Subject: Juniper Ridge Landfill Expansion Application, MEDEP #S-020700-WD-BI-N Follow-up to Department Staff's Responses to the March 4, 2016 Submittal on Staff's Review Comments as Presented in the Department's April 5, 2016 Letter

BGS AND NEWSME'S RESPONSE TO MEDEP'S APRIL 1, 2016 TECHNICAL MEMORANDA

I. April 1, 2016 Technical Memorandum Authored by Mr. Richard Behr

\\server1\CFS\Casella\OldTownLandfill\Expansion\9.35\MCY-Expansion\Project Regulatory Review\Acad\Figures\PumpTests-BR-TILL.dwg, 5/11/2016 12:51:43 PM, paf

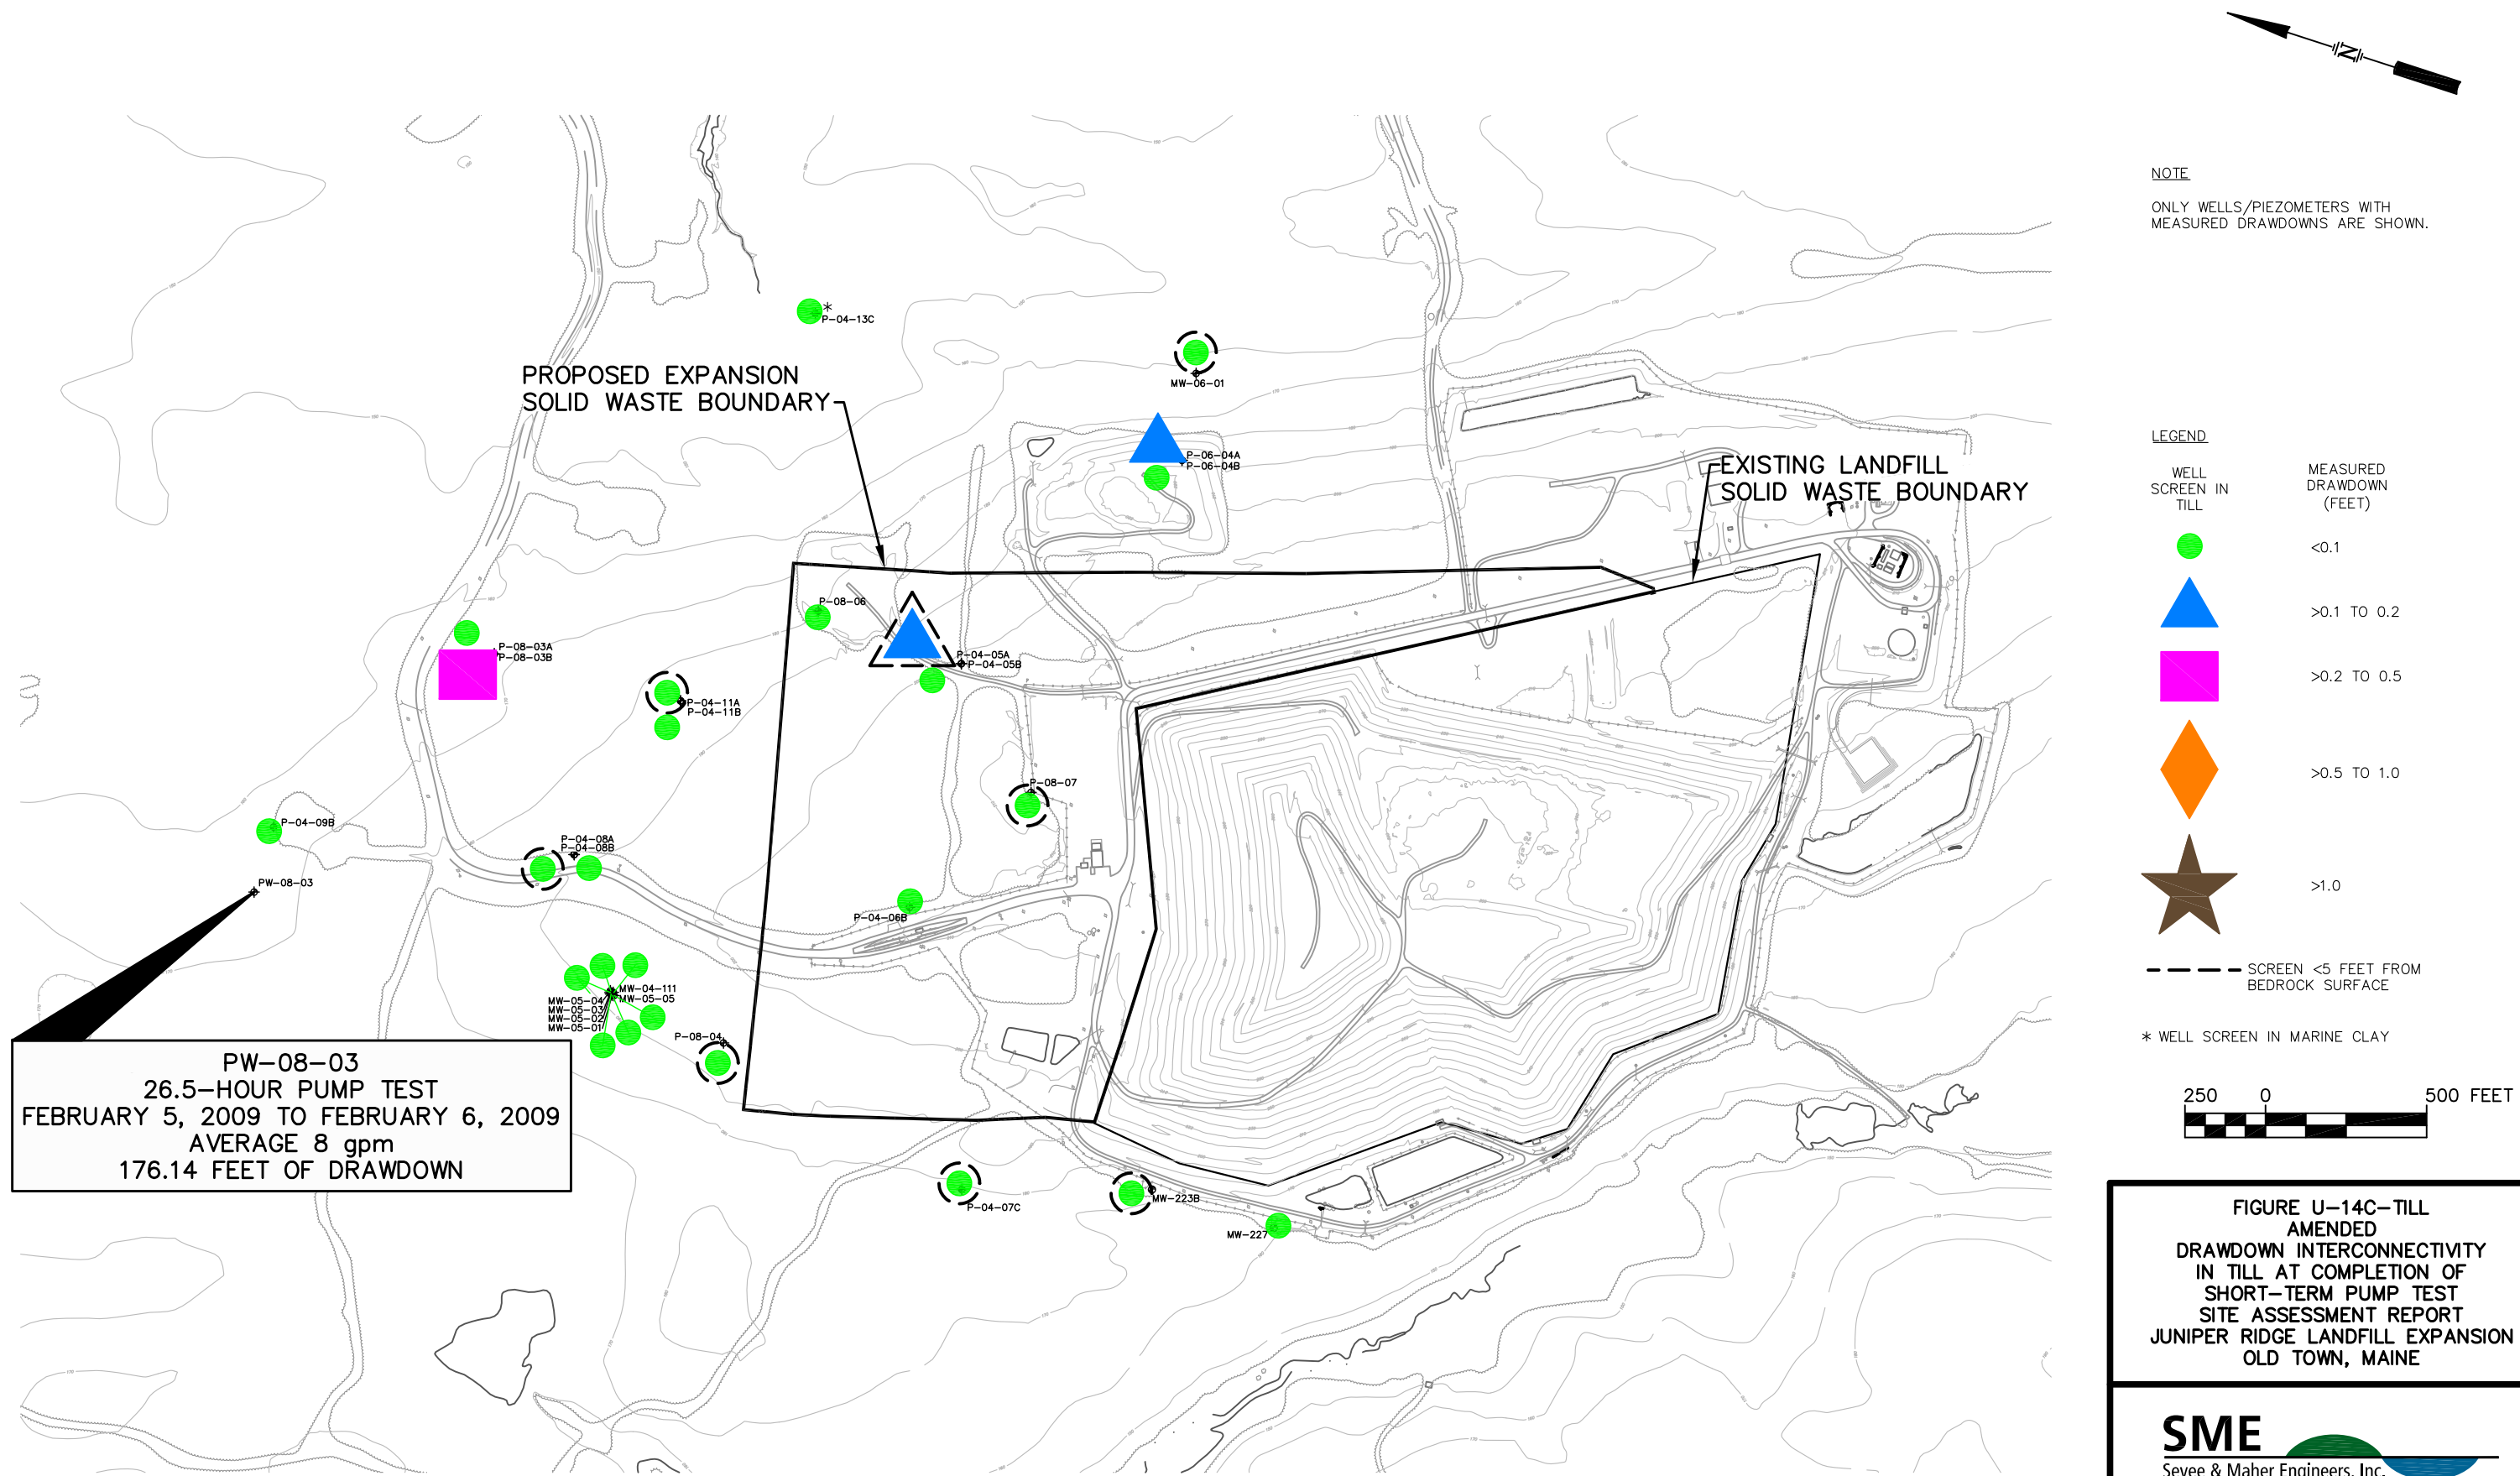
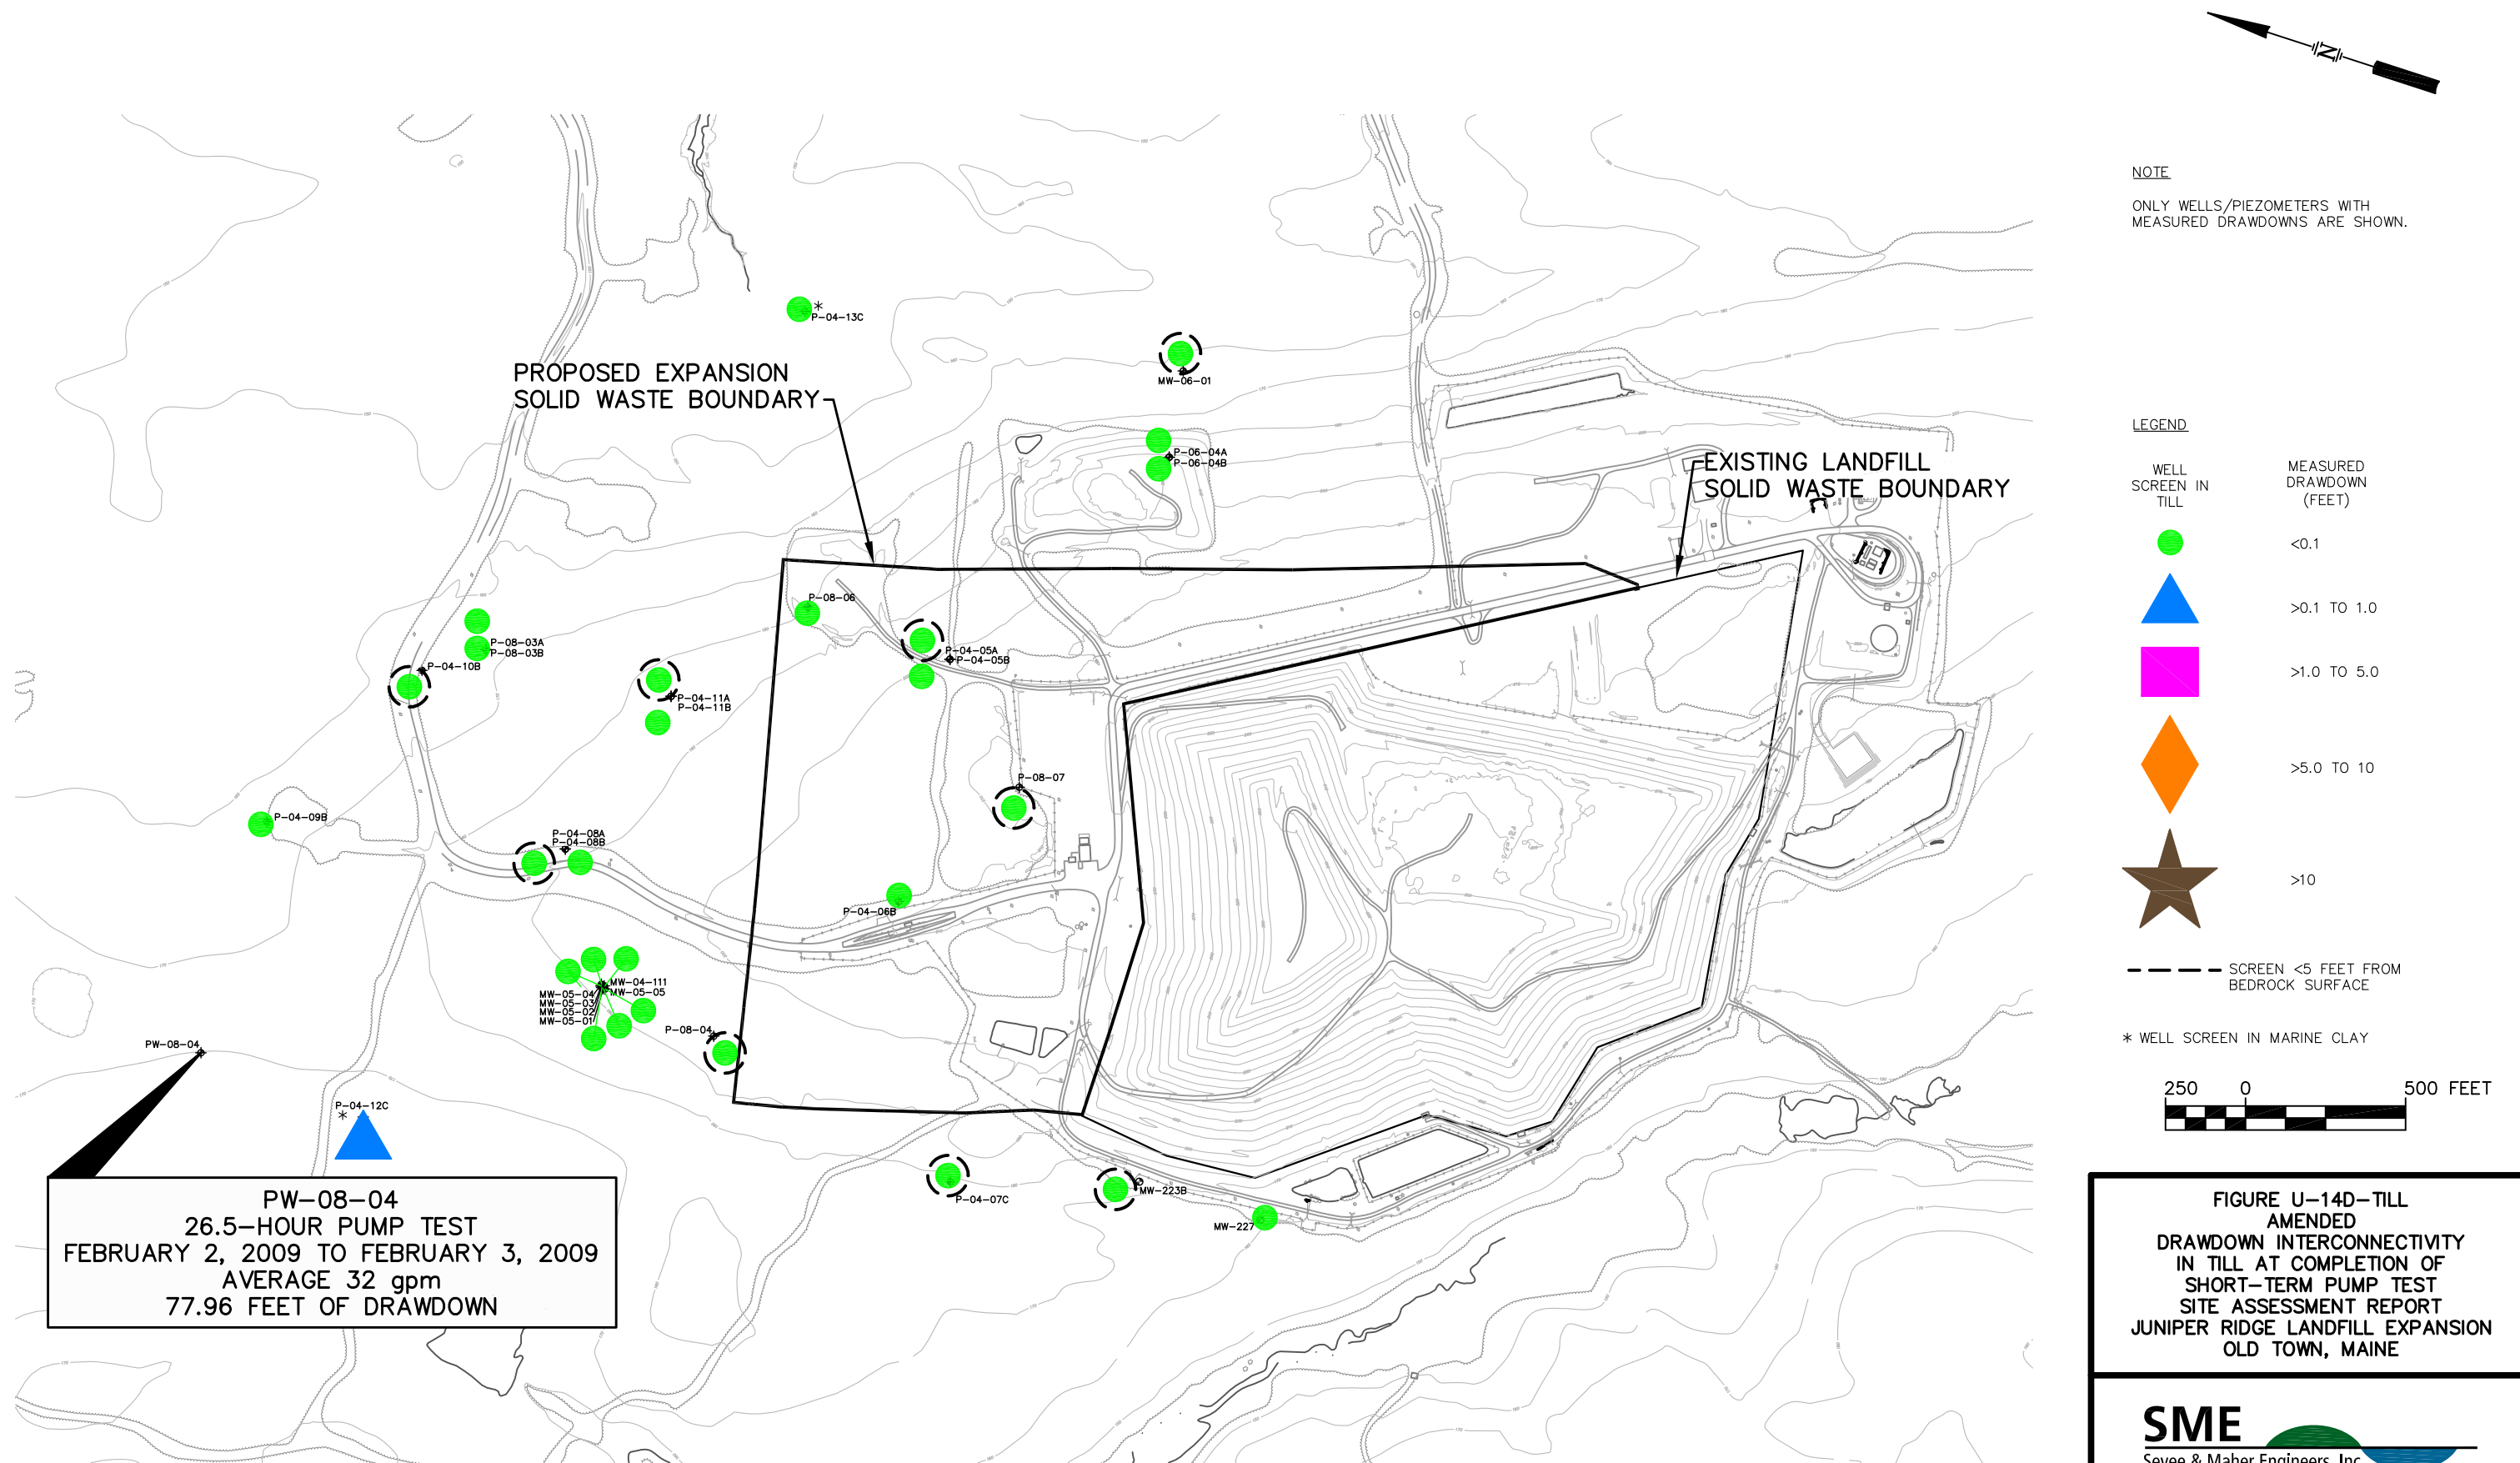
MEDEP Follow-on Response: My original comment included a request for figures to illustrate the observed drawdowns in monitoring wells screened in the till. JRL's

response did not include the requested figures. I continue to assert that a graphic depiction of locations where the till is hydraulically connected to the underlying bedrock is important and may assist in locating wells for long term monitoring and extraction wells in the unlikely event a significant leachate release were to occur.

MEDEP – Follow-on Response: The referenced figures were included in the original application but they do not differentiate the till wells from the bedrock wells. I continue to believe JRL should produce figures that depict the till wells where drawdowns were observed during the long-term pumping tests. These figures may help in the evaluation of long term monitoring well locations.

MEDEP – Follow-on Response: JRL's response to my comments about Figures U-14 and U-15 do not adequately address my comments. Additional figures are needed to properly illustrate the data collected during each of the five pumping tests. To further enhance the results of the pumping test data, it is necessary to include all of the drawdown data obtained during each test. Again, I contend it is important to differentiate between bedrock and till wells. As an example, the figure (Figure U-14) illustrating the 26.5 hour pumping test performed on PW-08-04, uses graduated symbols to depict the range of observed drawdowns for only 20 of the 53 wells where water levels were observed. There are also apparent inaccuracies on the existing figures. The text on page 26 states six wells (5 bedrock and 1 till) experienced between 0.1 and 1.0 foot of drawdown although Figure U-14 only depicts three wells in this range. The figure (Figure U-15) depicting the drawdowns observed during the long-term pumping tests at PW-08-01 and PW-08-02 also requires revisions as only a fraction of the drawdown data is depicted on this figure. Although JRL collected drawdown data for 53 wells during the tests, Figure U-15 only depicts data for 21 wells.

To address these comments, I recommend JRL display all of the drawdown data for each pumping test on appropriately scaled figures. I also ask JRL to augment the drawdown data included in Appendix M with a table summarizing the total drawdown observed in all wells during each of the pumping tests. This table would include those wells instrumented with pressure traducers and those where manual water levels were made. I am certain JRL has previously compiled this data to complete the pumping tests analyses. I also request that JRL also provide the Department with an electronic copy of the spreadsheet.

Applicants' Response: Included in Attachment SME-D3 are ten figures augmenting Figures U-14 and U-15 included in Appendix U of Volume II of the Application. These figures show monitoring wells and piezometers where drawdowns were measured during the pumping tests. For each pumping test two figures, one showing the drawdown in the bedrock, and one showing the drawdown in the till, have been prepared. On the figures showing the drawdowns in the till the locations where the instrument screen is located within five feet of the bedrock surface are identified.

Applicants' Response: See previous response to the comment regarding Appendix U, Pg 25, 5.0 Pump Test Proof of Bedrock Interconnectivity. These figures are contained in Attachment SME-D3.

Applicants' Response: See previous response to the comment regarding Appendix U, Pg 25, 5.0 Pump Test Proof of Bedrock Interconnectivity. The augmented U-14 and U-15 figures are contained in Attachment SME-D3.
